Subject: FCC Class II Permission Change Request for FCC ID: HD5-HAQ

This is to request a Class II Permission Change Request for FCC ID: HD5-HAQ, originally granted on 2018/05/24.

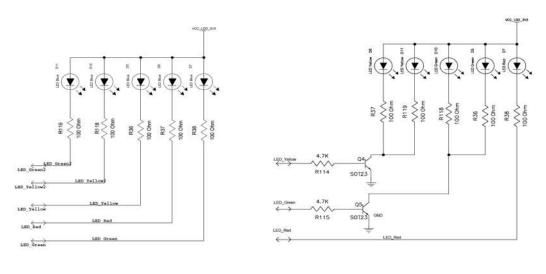
- 1. Schematic diagram design change:
 - (1) Add a filter capacitor C1, add a connection (HD) from U16 Pin5 to MCU pin59

(2) Modify LED control circuit

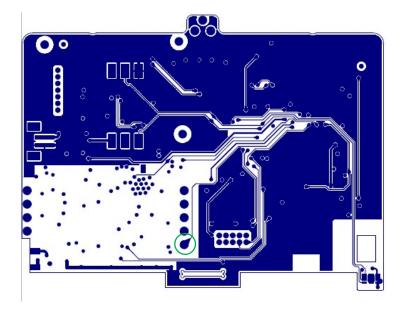
Old design

New design
